**SUBDIVISION, PLANNING APPROVAL, &
SIDEWALK WAIVER STAFF REPORT****Date: August 17, 2006****NAME**

Greater Macedonia Baptist Church Subdivision

CONTEMPLATED USENew fellowship hall and parking lot expansion at existing
church in R-1, Single-Family Residential district**TIME SCHEDULE
FOR DEVELOPMENT**

SITE PLAN

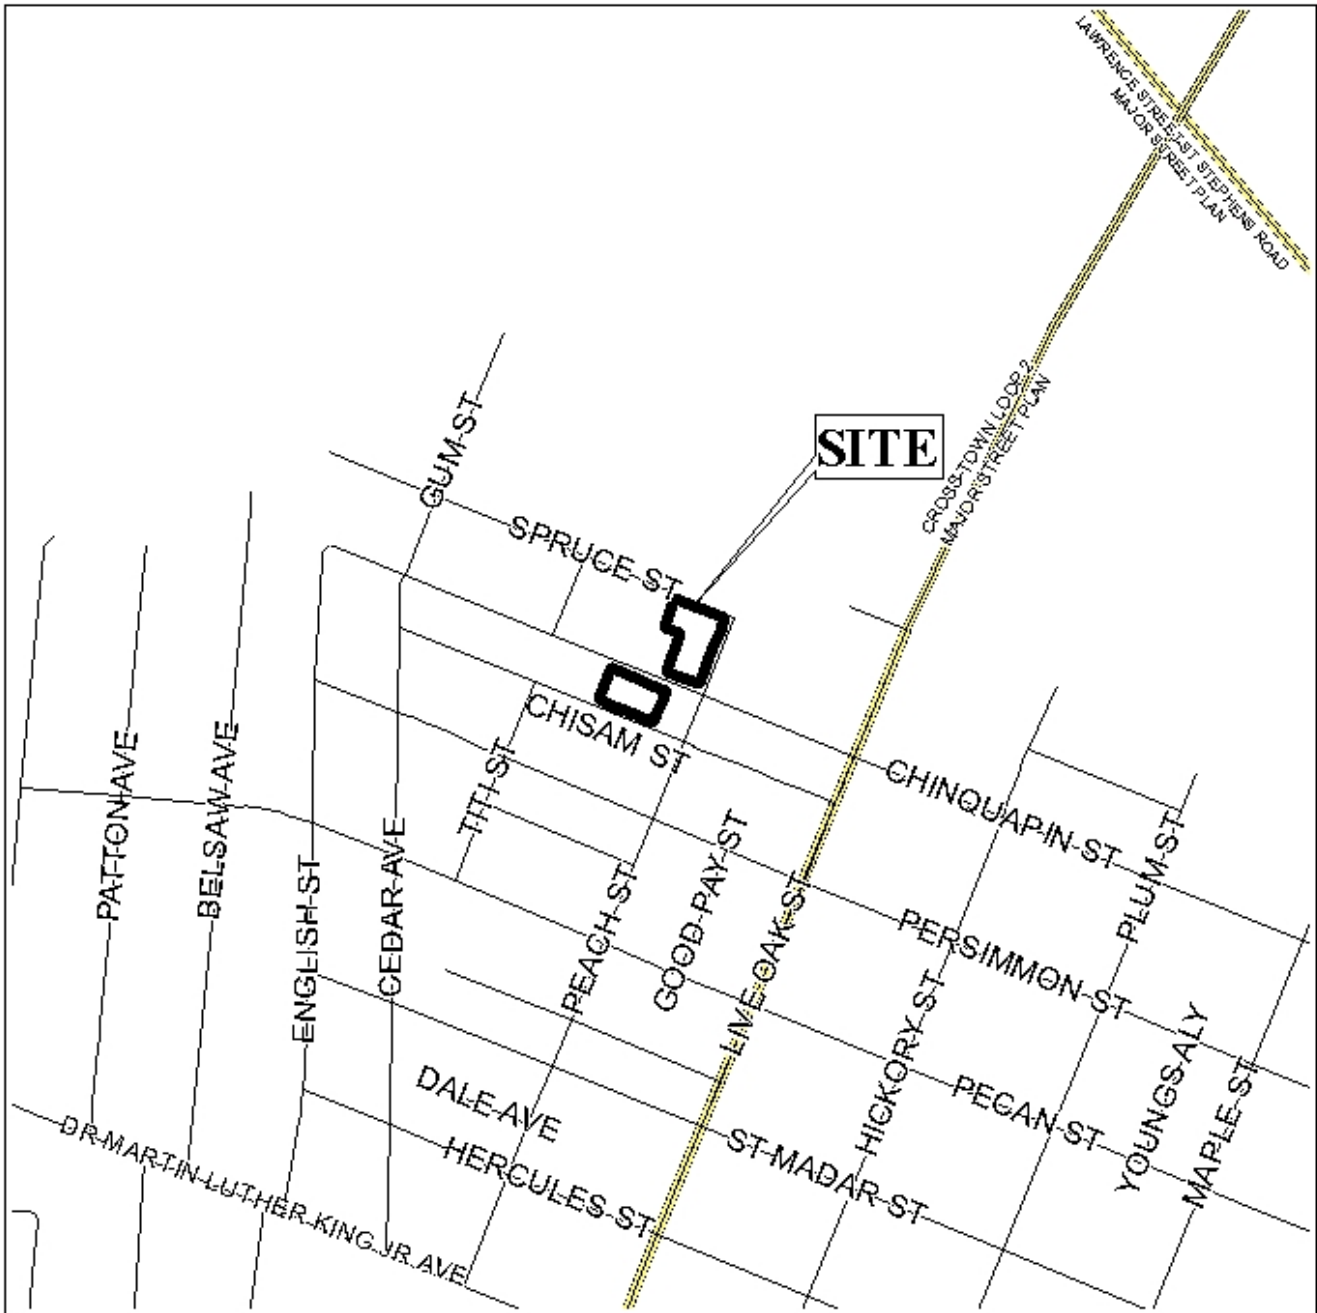
It should be noted that an existing structure to the West of the site is shown crossing the Western property line of Proposed Lot 1. This structure should either be removed, or the other parcel should be brought into the subdivision to redraw the property lines to eliminate encroachment across the property line and to provide for adequate setbacks.

Regarding the proposed Planning Approval, the site plan shows a fellowship hall to be constructed at the North side of the church (on proposed Lot 1); and additional parking to the East of this proposed addition, as well as on proposed Lot 2, to the South (across Chinquapin Street). The applicant states that the church will accommodate 160 people, and shows 40 spaces to meet the requirements for a church of that capacity. However, there are some issues with the parking layout.

Several required spaces are located in the right-of-way; those are existing, so they may be retained. However, the existing concrete drive should be removed. Due to the angle of the existing parking on Lot 1, cars should enter the lot from Chinquapin Street and exit onto Peach Street, through only one curb cut per street. This will cost the site some required parking spaces, but improving the circulation may take precedence over providing the minimum number of parking spaces, especially given that the overall parking deficit is being reduced for the site.

A result of the existing parking in the right-of-way is that trees cannot be planted along the street frontages, as required by the Zoning Ordinance. The site plan actually shows almost all required trees and landscaping concentrated on the Northwestern portion of proposed Lot 1. While the existing parking need not be removed to make room for landscaping, frontage trees should be provided wherever it is physically possible; those that would have been required where the parking is located may instead be planted in the Northwestern corner of the site, as proposed.

Thus, the site plan should be modified to show revised parking, maneuvering, ingress, and egress, with no more than a single curb cut to each street frontage; and to show that the tree planting and landscaping provisions of the Ordinance are satisfied to the extent that it is possible. It should also be noted, when planning the landscaping, that the site has five street frontages, including Chisam Street, since proposed Lot 2 is a double-frontage lot; trees and landscaping will be required on all frontages.

Planning Approval: Based upon the preceding, this request is recommended for Holdover to the September 21st meeting, to allow the applicant to submit revised materials illustrating revised parking, maneuvering, ingress, egress, and landscaping; and showing fewer curb cuts; and illustrating the Chisam Street frontage and right-of-way. Revisions should be received by August 28th.
